## 1990 Corvette: Service Bulletin: L98 and LT5: Revised Air Conditioning Control Circuit Diagnosis

Subject: REVISED AIR CONDITIONING CONTROL CIRCUIT DIAGNOSIS Model and Year: 1990 CORVETTE WITH 5.7L L98 AND LT5 ENGINES Source: Chevrolet Dealer Service Bulletin Bulletin Number: 90-400-6E

Revised A/C Control Circuit Diagnosis

CHART C-10

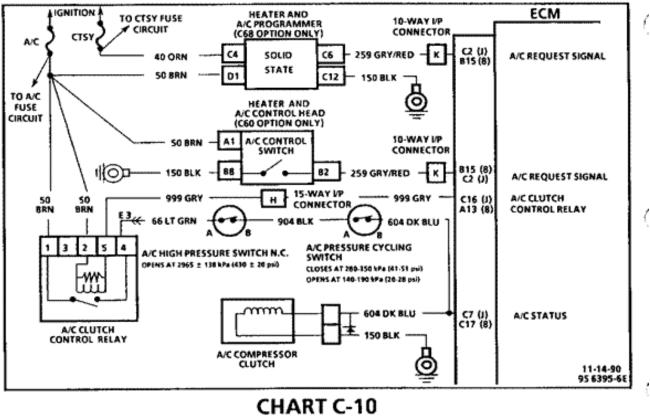
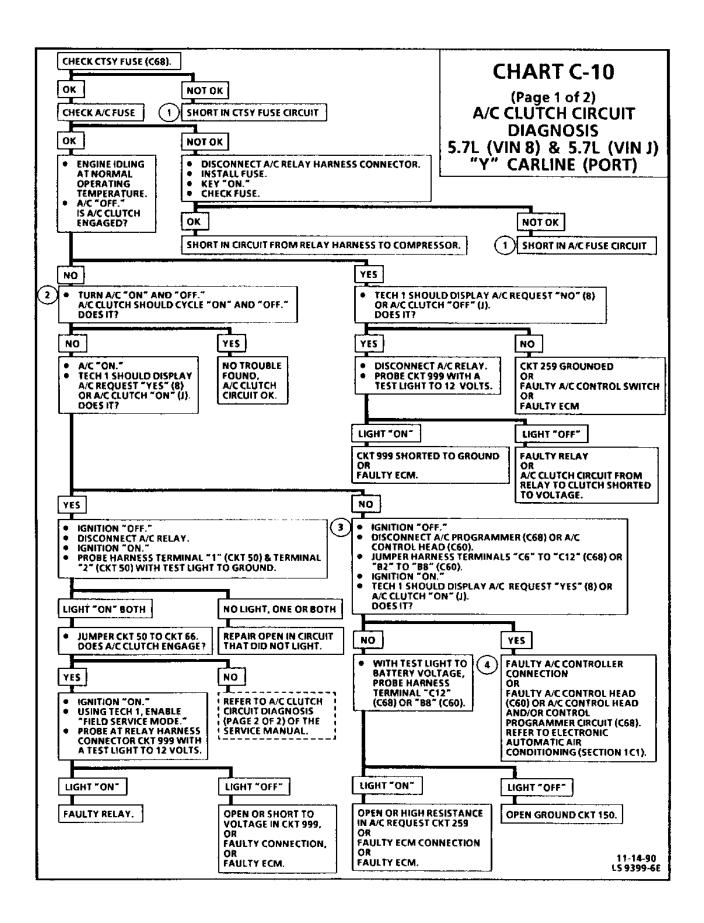
The following information updates the A/C clutch circuit diagnostic chart and facing page information found on pages 6E3-C10-4 and 6E3-C10-5 in Section 6E3 "Driveability And Emissions" for the 1990 "Y" 5.7L L98 (VIN 8) and LT5 (VIN J) Corvette Service Manual.

The A/C clutch control relay is ECM controlled to delay A/C clutch engagement after

the A/C is turned "ON." This allows the ECM to adjust engine rpm before the A/C clutch engages.

The ECM will engage the A/C clutch any time A/C has been requested unless any of the following conditions exist.

o High coolant temperature. o Wide open throttle. o High oil temperature. o Sustained high vehicle speeds (LT5). o High engine rpm.

The ECM can determine A/C request by sending a voltage signal to the A/C control head. When the A/C control switch is closed, the A/C request voltage signal is grounded. This is shown on the Tech 1 as A/C request "YES" (8) or A/C clutch "ON" (J).

When a request for A/C has been detected by the ECM, the ECM will ground the A/C clutch control relay drive circuit, the relay contacts will close and energize the compressor clutch portion of the circuit. If the system is properly charged, the circuit will be complete to the A/C compressor clutch.

When A/C request has been detected by the ECM, the cooling fan(s) will be turned "ON" unless vehicle speed is too high.

1. Refer to ELECTRICAL DIAGNOSIS (SECTION 8A) "FUSE BLOCK DETAILS" for fuse circuit power distribution.

2. Checks the ECM's ability to control the A/C clutch control relay.

3. Checks to determine if the ECM is capable of detecting the A/C request signal being grounded.

4. Before replacing C68 A/C control components," refer to ELECTRONIC AUTOMATIC AIR CONDITIONING (SECTION 1C1) for further A/C diagnostics.
